## Product Change Notice (PCN)

**Subject:** Assembly site transfer for Low Power SRAM 48-ball FBGA products

# Shipping label specification:

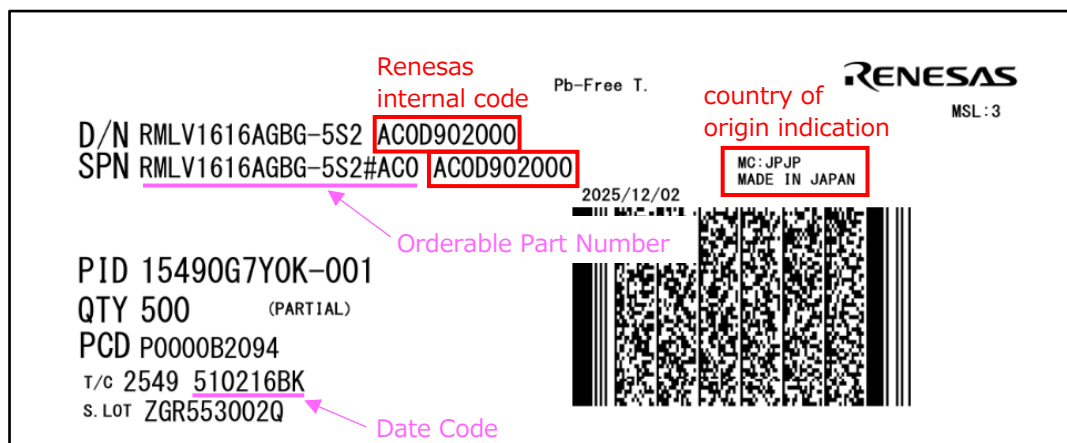
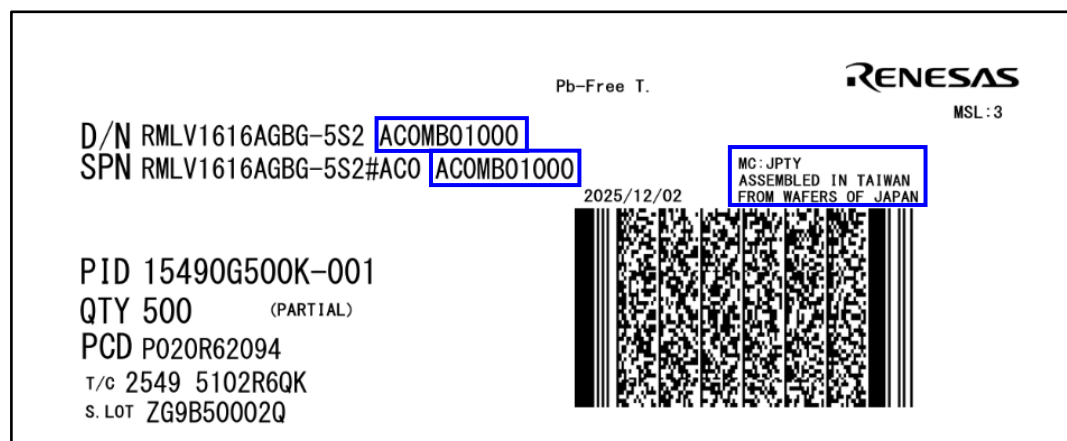
- Label format itself is unchanged.
- Written specifications: “Renesas internal code” and “country of origin display” are changed.  
See below for example.
